#### PLANNING COMMISSION WORKSHOP AGENDA

Wednesday, December 20, 2023 | 3:00 p.m.
Planning & Building Dept. Conference Room – 196 Laurel Street

**PIN: 368-07-01-0101** (**Lot 90, Rollingson Subdivision**) – The applicant, Jamie Steele, Diamond Shores. is requesting a design modification to allow for the issuance of a building permit on an existing lot of record that lacks frontage onto a publicly maintained street.

*Previously Deferred* ...Proposed Development Agreement by Lennar Carolinas, LLC and Thomas & Hutton, for proposed development of property located on Hwy 378, Juniper Bay Rd, and Dunn Shortcut Rd, to be known as the Tributary Planned Development, and consisting of approx. 486 +/- acres (PIN's 336-00-00-0043, -0044, -0045, 336-13-04-0006, 336-14-04-0011, 336-15-03-0003, 370-00-00-0011, 370-04-01-0004, 337-00-00-0009, -0011, -0012, and 337-08-01-0004).

Other exhibits

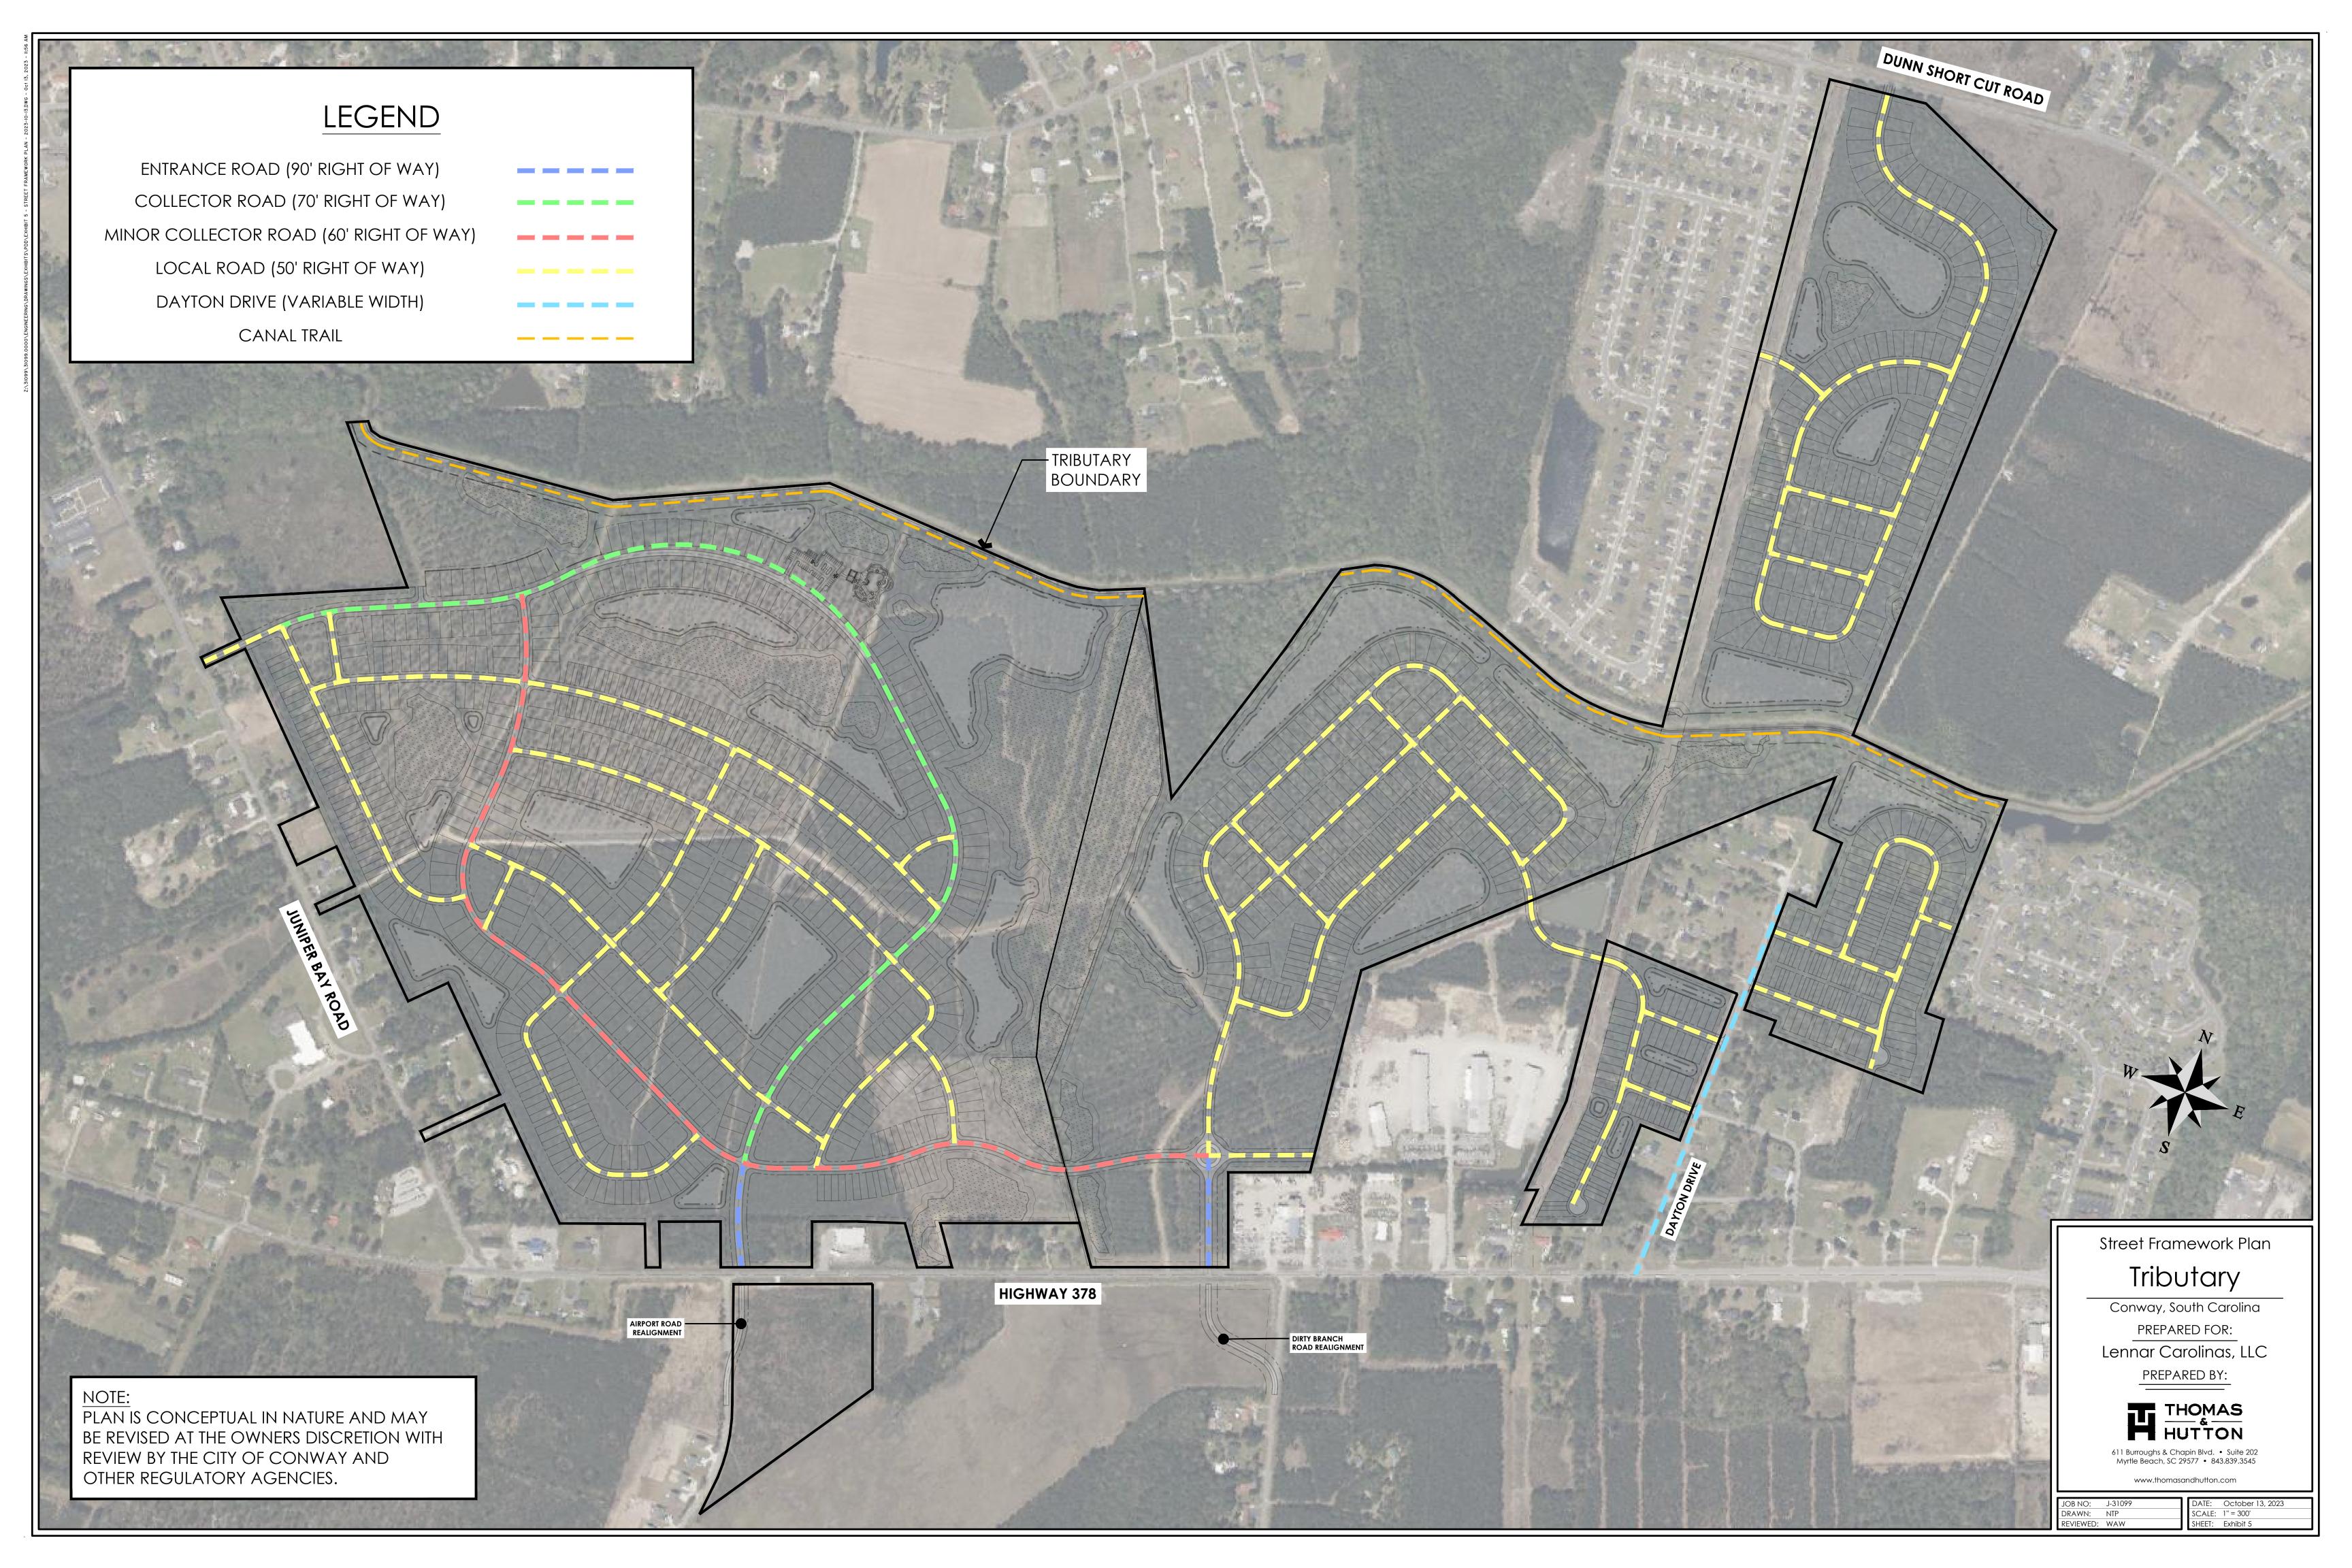
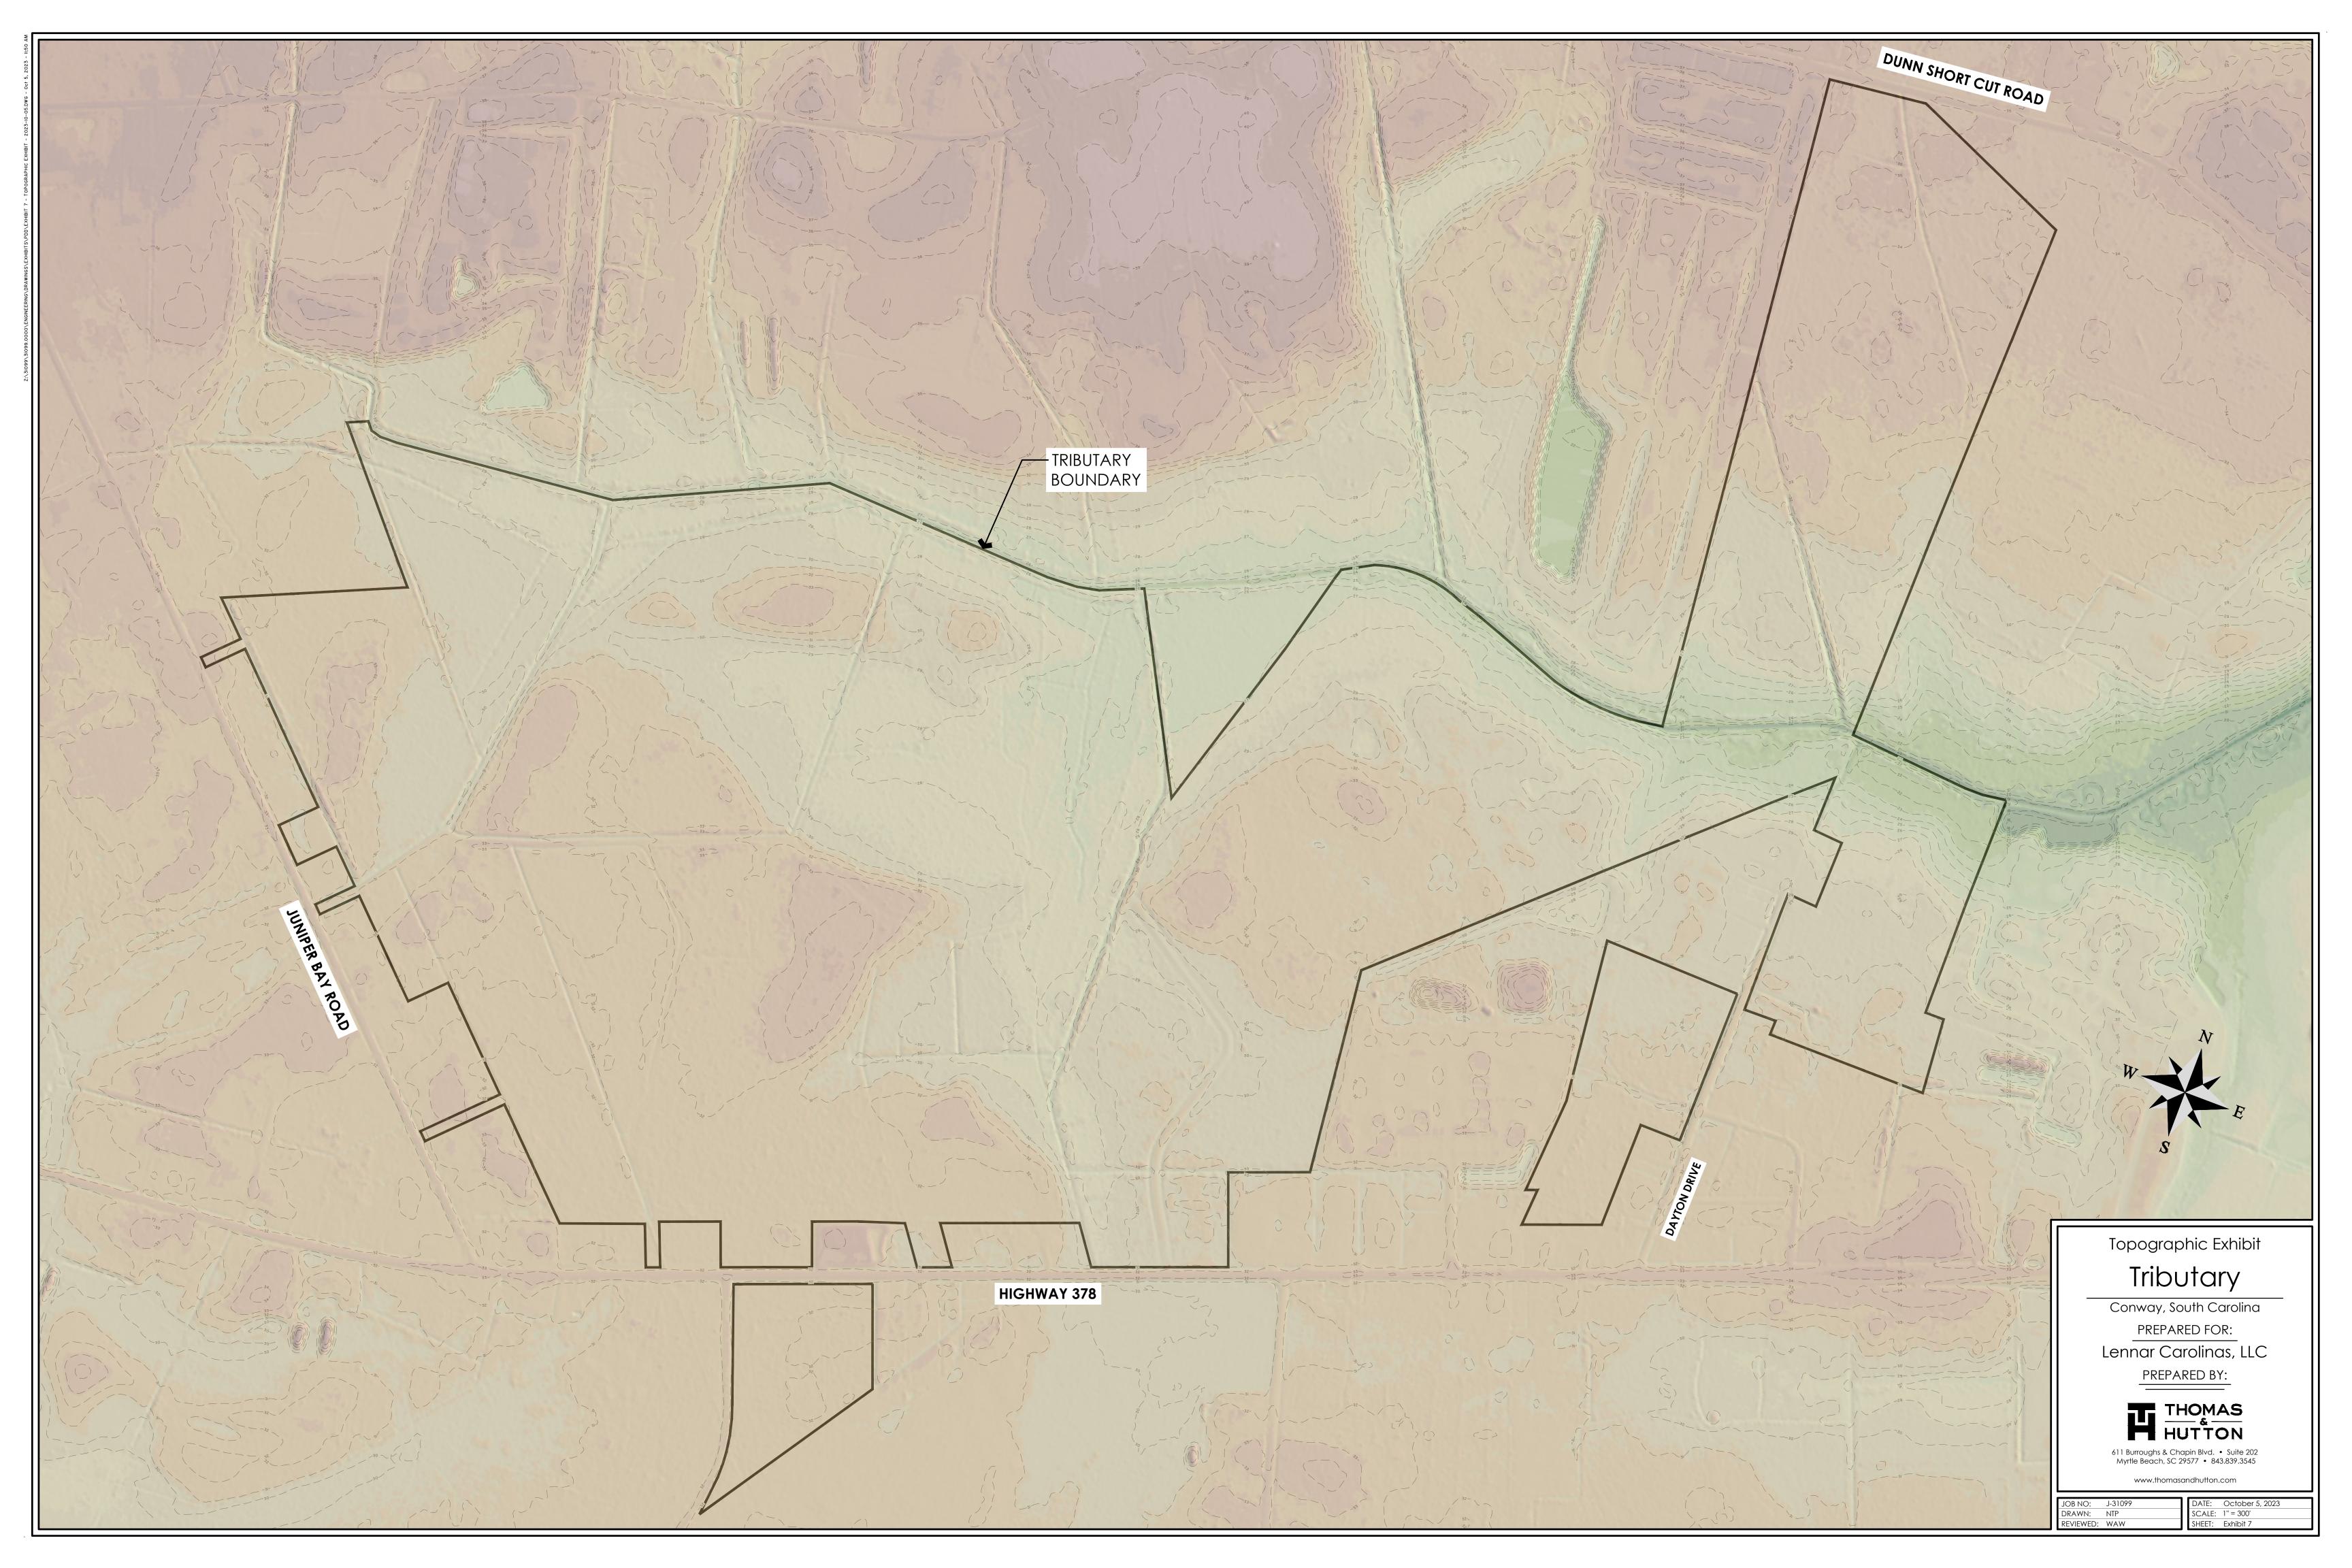
PD NARRATIVE COMMENTS			
PD Narrative Section	Issue	Additional Info / staff Comments	
Section 1: Purpose and Intent Statement	(pg. 4) Reference to nearby regional roadways: includes Highway 701 S, but not Highway 378. Is this intentional?		
Section 2: Development Summary	(pg. 4) 1 <sup>st</sup> paragraph: Remove reference to Sec. 6.4.2 of the UDO.	Just specify "in accordance with the City of Conway UDO"	
	(pg. 4) 3 <sup>rd</sup> paragraph: "transfer of units between districts"	should this be tracts or phases instead?	
	(pg. 4) 3 <sup>rd</sup> paragraph: transfer of units between tracts	The flex tracts proposing multifamily should not be included in the transfer of densities between like tracts. This should be restricted between the "R" tracts.	
	(pg. 4) 3 <sup>rd</sup> paragraph: "use districts shall be capped at 125% pf the density shown in the development summary table"	Staff would prefer that the wording be revised to state something similar to "density may be shifted between tracts with like uses, provided that the <b>overall</b> density across the entire PD/across all tracts is not increased"

(pg. 5) Use District column: Flex District F-1 and Flex District F-2.	Type column: only multifamily or townhome is listed. Shouldn't this include commercial as well?	
Development Summary Table	(pg. 5) Use District column: Commercial C-1 and Commercial C-2	Type column: shouldn't Light Industrial (LI) be added also?	
Section 3: Permitted Uses and Dimensional Requirements			
Dimensional Standards		Staff comment: Lot widths are very dense for this area (20' to 52' lot width, which vary throughout the project area)	
Section 4: Additional Requirements	(pg. 8) 7.A.: remove reference to Section 10.3.9	remove "Section 10.3.9" from sentence.

throughout the PD	(pg. 9)		Will the buffer be
District	8. Landscape Buffers and	PD External Perimeter Buffer	increased to 50' where
District	Quantities		adjacent to existing,
	Quantities		adjacent residential
			properties, as previously
			discussed?
			aiscussea?
			Remove reference to
		Footnotes 1 and 2	specific section of UDO

(6.5.2)
Section 5: Design	1. Landscape buffers between		
Standards and	commercial uses shall not be	Which tracts will these be applical	hle to?
Modifications	required.	Willest tracts will these be applical	ole to:

(p. 10)			
(β. 10)	2. Where multi-purpose trails are parallel to and within		
	·	These locations should be illustrat	ed on an exhibit (i.e.
	required landscape buffers, the	street framework plan)	
	width shall be reduced to a Type		
	A buffer.

(p. 11)	timing of such conveyance,	case includes areas being conveyed to the City will include,	
	installation of improvements,	should be installed and usable by residents within a	
	dedication, etc., shall be	development.	
	negotiated between the	development.	
	developer and City Council.		
	TRAFFIC IMPROVEM	ENTS (ON SITE & OFF-SITE)	
ONSITE (w/ in	Local Road (see exhibit and the	50' right-of-way (ROW); however, each lane is only	
project area)	Street Framework Plan)	proposed to be 11' in width, making the pavement width a	
		total of 22', with 2' curb/gutter, 6' shoulder/planting strip,	
		an 8' multi-use path on one side of roadway, and 5'	
		concrete sidewalk on other side of road. The minimum	
		pavement width should be 24'.	
	Minor Collector Road (see	60' ROW with 24' pavement width (12' each side), 2'	
	exhibit and the Street	curb/gutter, 6' shoulder/planting strip on each side of road,	
	Framework Plan)	an 8' multi-use path on one side of roadway and 5' concrete

Flamework Flam	sidewalk on other side of road.	
	Callanta a Band		
	Collector Road	70' ROW with 28' wide pavement width, 2' curb/gutter, 8'	
		shoulder/planting strip on both sides, an 8' multi-use path	
		on one side and 5' sidewalk on the other side of the road.	
	Entrance Road (collector)	90' ROW with median (24' pavement width on one side of	
		median and 14' pavement width on other side of median),	
		2' curb/gutter, 8' shoulder/planting area on each side of	
		road, 8' multi-use path on one side of roadway and 5'	
		concrete sidewalk on other side of road.	
	Dayton Drive (variable width)	Dayton appears to be an approx. 50' ROW at the point in	
		which tracts R-3 and R-4 will be accessed; however, the	
		entrance to Dayton from Hwy 378 is smaller – approx. 30' in	
		width, and in order for the project to be compliant with	
		roadway standards of the UDO, the entire roadway (Dayton	
		Dr) must come into compliance. The applicant may have to
